Bridge Repair on I-55 over Long Creek (Bridge Nos. 237.7A & 237.7B), known as Federal Aid Project No. NHPP-0055-04(110) / 108458301 in Panola County.

SECTION 904 - NOTICE TO BIDDERS NO. 2969

SUBJECT: Plan Note Correction

ADDENDUM

1 OF 11 SHEET NUMBER

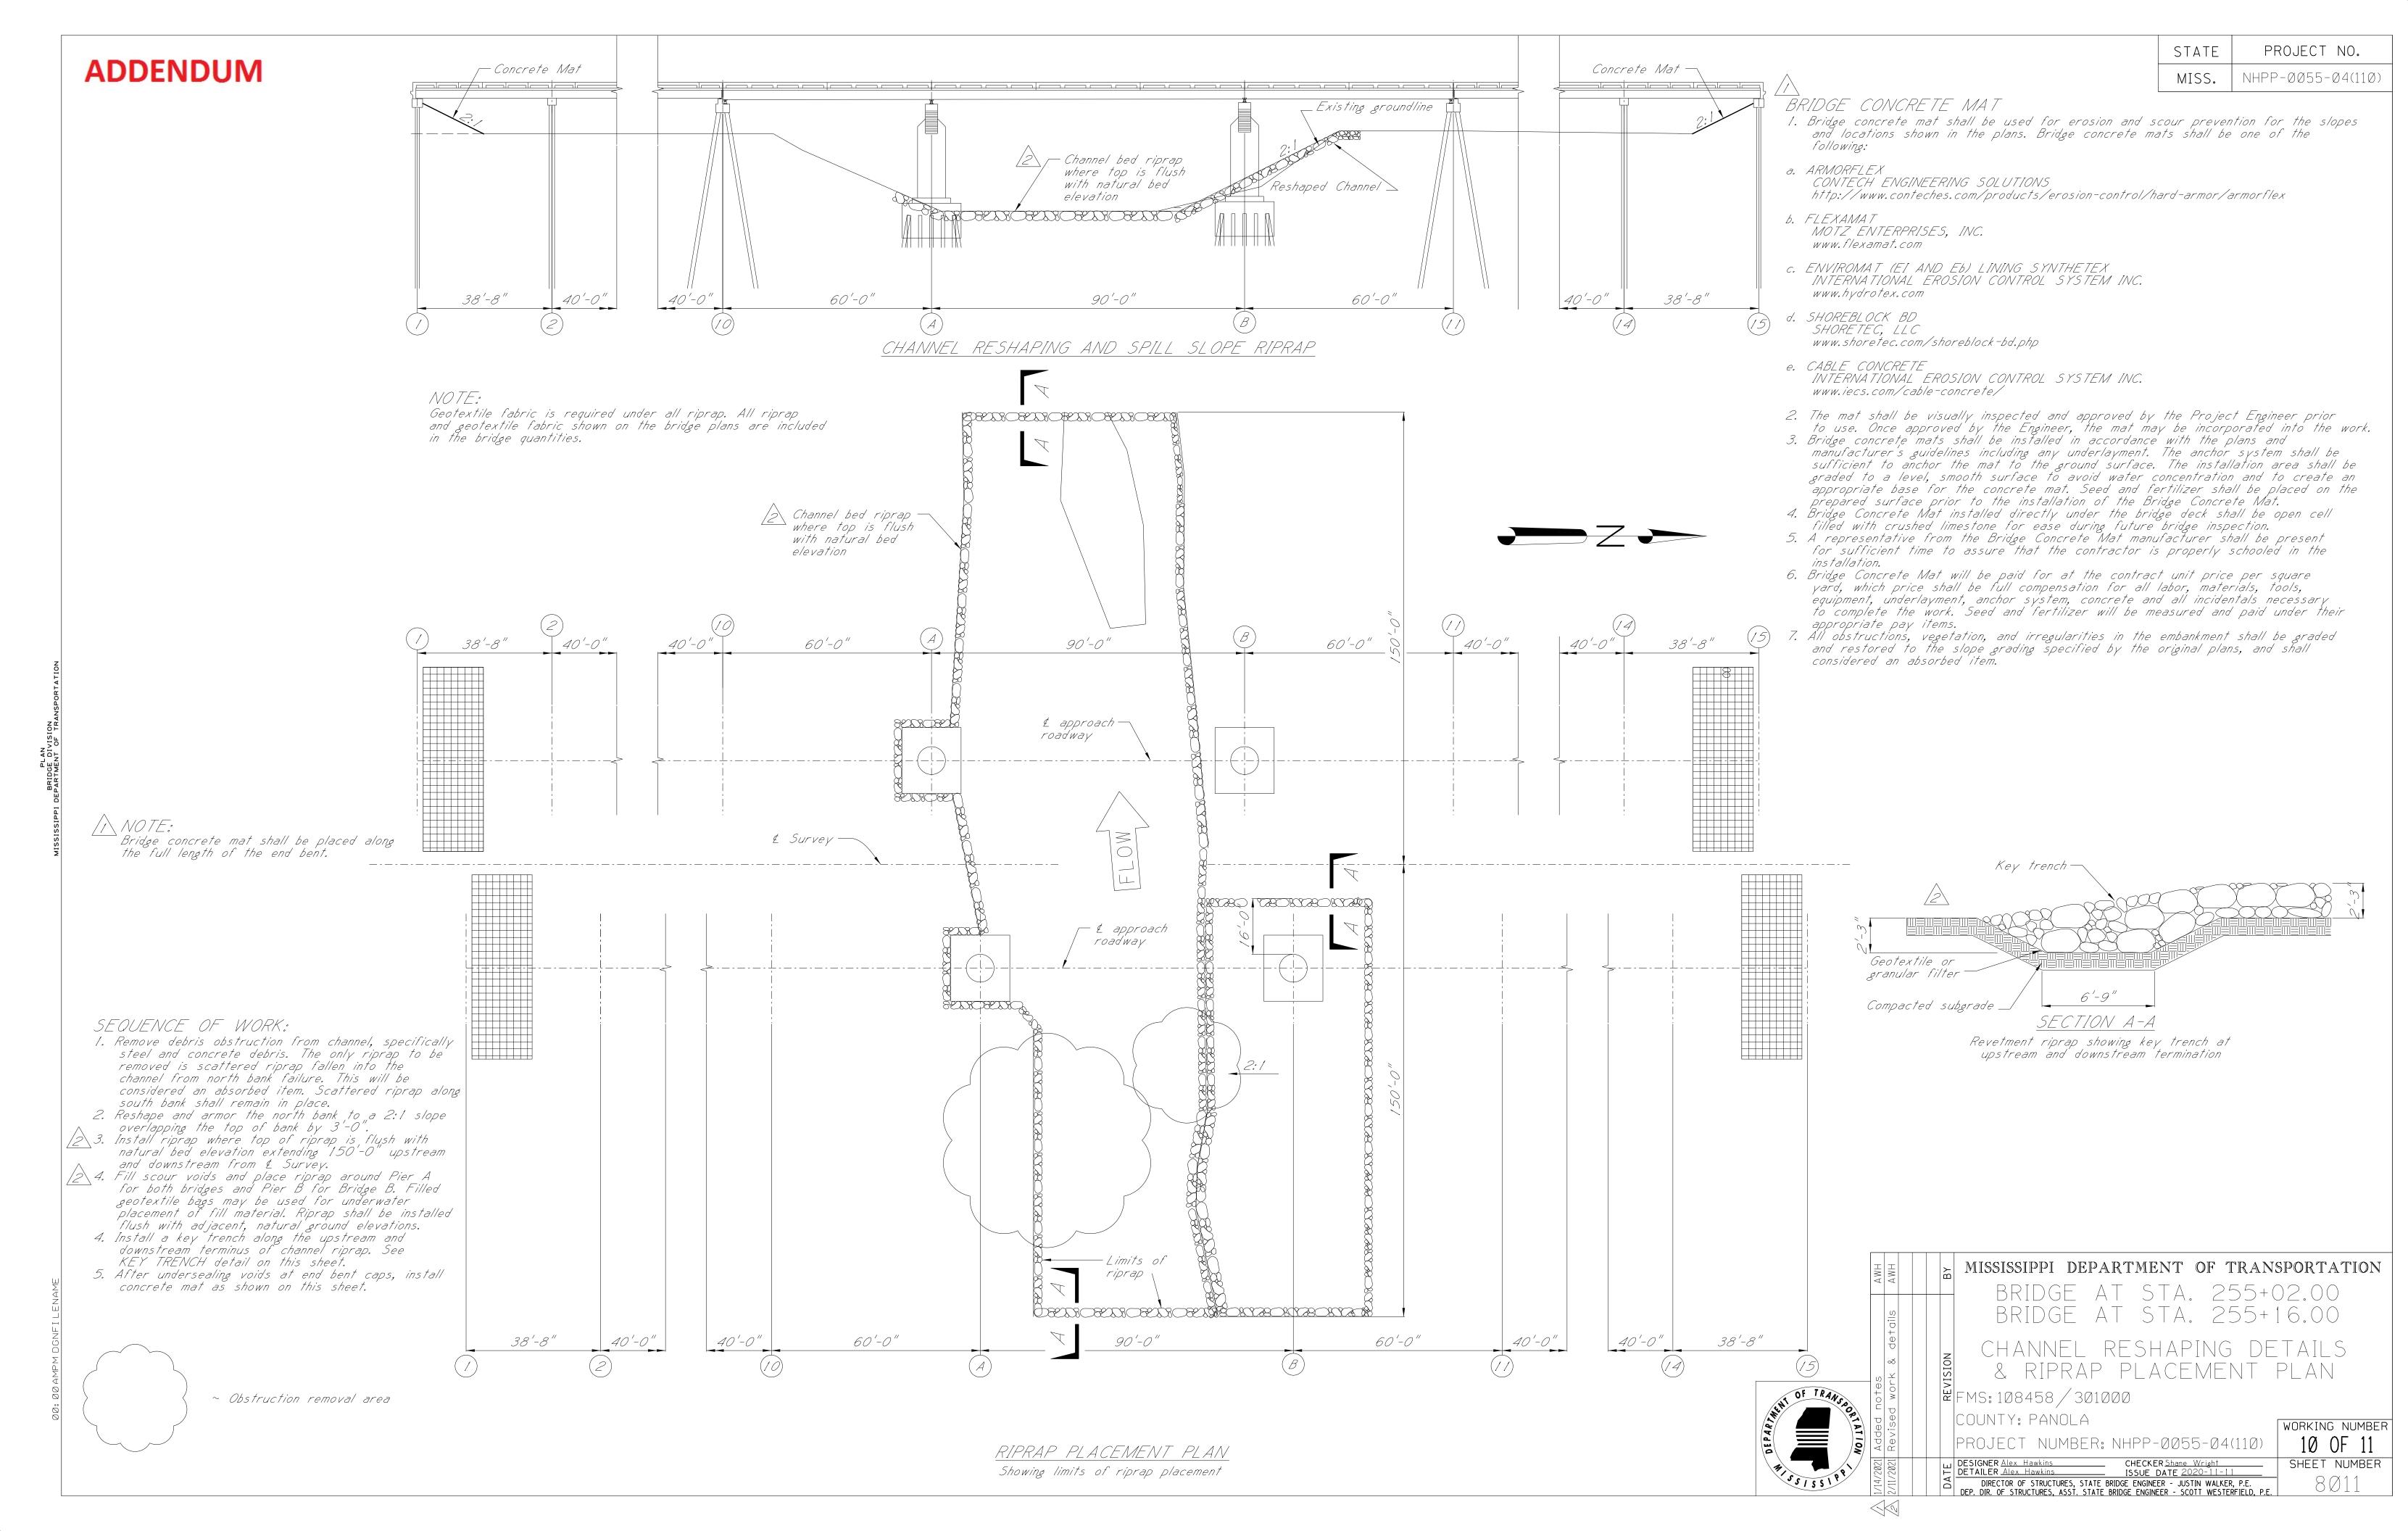
The Bidder's attention is called to the second sentence in the first paragraph on Sheet 8002, under the section titled "Abrasive Blasting and Painting" of the plans.

"The square footage of 8,000 sq. ft. given for this item is for informational purposes only and is approximate and will not be measured for payment." This is in error. The sentence should read: "The square footage of 25,000 sq. ft. given for this item is for informational purposes only and is approximate and will not be measured for payment."
